Subject: Response to Notice of Deficiency dated October 1, 2001 – Pond 17 Closure Plan, Astaris Idaho LLC.
EPA ID No. IDD 07092 9518

EPA GENERAL COMMENTS and ASTARIS RESPONSES

POND 17 CLOSURE PLAN

SMOKE GENERATION TESTS

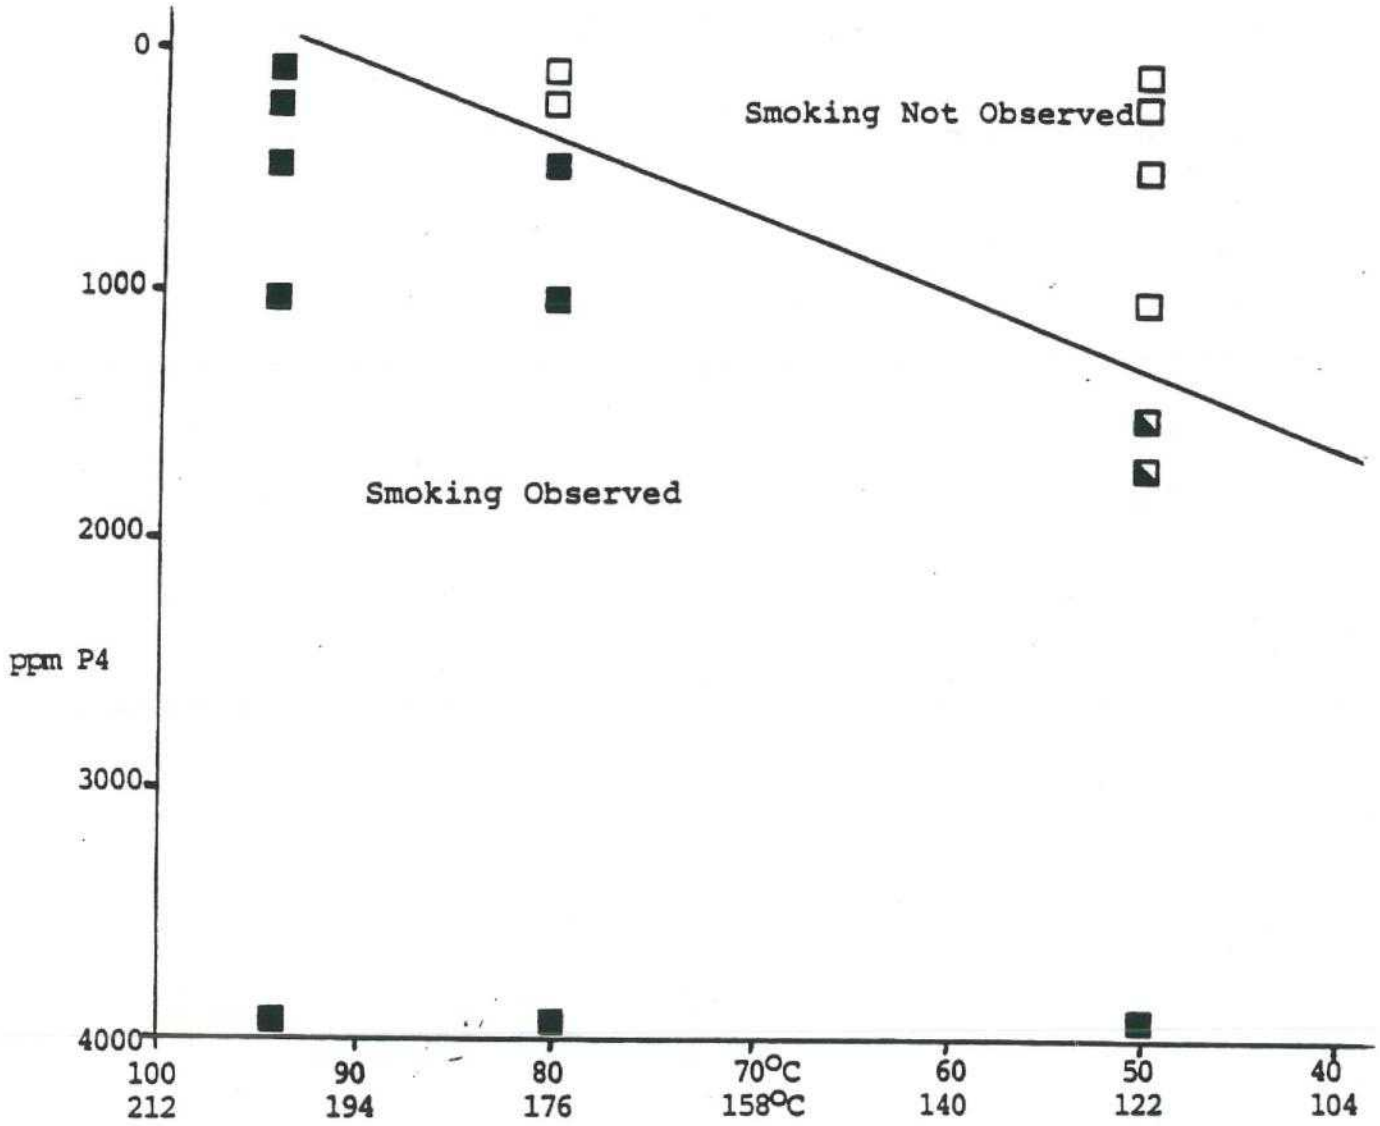
1. Page 1-1, Fourth Paragraph and Section 2.3.1, Page 2-5.
   These paragraphs state laboratory test information on the NOSAP slurry and observations from Pond 8E, have shown that NOSAP slurry does not smoke or burn when allowed to dry. The referenced laboratory data must be provided. Since the Closure Plan proposes to allow the water level to drop, which may allow the solids to oxidize, additional information must be provided demonstrating that the Closure Plan is protective of human health and the environment. Since phosphorus pentoxide smoke converts to phosphoric acid upon exposure to moisture, plans for minimizing emissions of both phosphorus pentoxide and phosphoric acid must be included in the Closure Plan. A method to monitor and measure phosphorus pentoxide and phosphoric acid must be included in the Closure Plan.

Response: Astaris development of the NOSAP process included an evaluation of the elemental phosphorus threshold concentration at which materials smoked or burned. A copy of the laboratory procedures and results are contained in Attachment 5 to this response document. Since only on-specification NOSAP slurry was placed in Pond 17, there is a very low potential for burning or smoking from exposed NOSAP solids at Pond 17.

Even on a hot day when surface temperatures at a landfill are over 100°F, or slightly higher, the "non-smoking" limit for the treated waste can still be conservatively set at 1000 ppm phosphorus on a wet basis. The limit on a dry basis depends on the dewatering method used but could be as high as 2000 ppm phosphorus. It is recommended that the phosphorus limit in the full scale PWMP plant be set at a maximum of 500 ppm to allow for processing variances.

This conclusion is consistent with the traditional "rule of thumb" often quoted from past experience at the Pocatello plant that 1000 ppm P_4 content is non-smoking. The conclusion is also consistent with observations made during the operation PWMP pilot plant and associated sampling. Of all the phossy waste that was treated and subsequently dewatered no smoking was observed from the damp cake or any dried cake. Phosphorus levels in the treated waste over the course of the PWMP pilot operation ranged from 10 - 570 ppm.

TREATED PHOSSY WASTE PRODUCTS TESTED ON LAB HOT PLATE
CONCLUSION: 1000 PPM P4 LIMIT APPEARS JUSTIFIED
